Gen 5 DD13 Turbo Oil Drain Tubes Cracking

Description

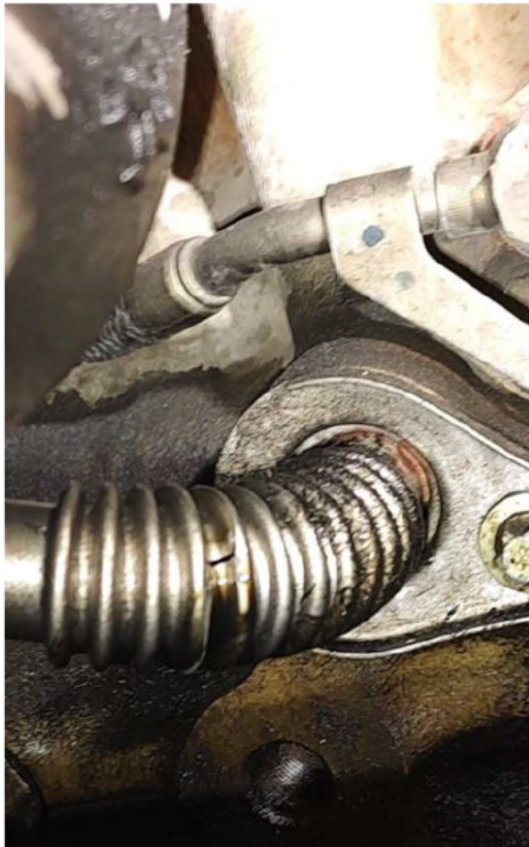
- Gen 5 DD13 turbo oil drain tubes are cracking and causing oil leaks. Based on returned material, missing turbo support bracket bolts appear to be a large contributing factor.

- **ICAs**
 - Workshop manual improvements – **First round published 07/30/24**. More improvements in process.
 - 24CSA-17 letter advising dealers to replace the turbo support brackets and hardware along with the broken tube. **Published 09/23/24**. Working to convert to a TS letter to incorporate into TechLane.

- **PCAs**
 - Assembly line installation sequence change to reduce stress on the tube. **Implemented 10/23/24**
 - Optimizing turbo bracket bolt tightening program to eliminate “re-hitting” an already tight bolt. **Implemented 12/04/2024**.

- Proposed 100% quality check of turbo bearing housing angle. **Evaluation ongoing**.
 - Proposed increased torque to turbo support bracket bolts. Current assembly line torque 25NM. Current service procedure is 30NM. **Process in review**.

- Proposed increased length to turbo support bracket bolts. **Change in review**.
 - Eliminate supplier quality defects on turbo support brackets as seen in field returns. **Discussion ongoing with supplier**.

- Replace the turbo oil drain tube. Check the turbo mounting brackets for cracks or loose/missing bolts. Follow 24CSA-17.
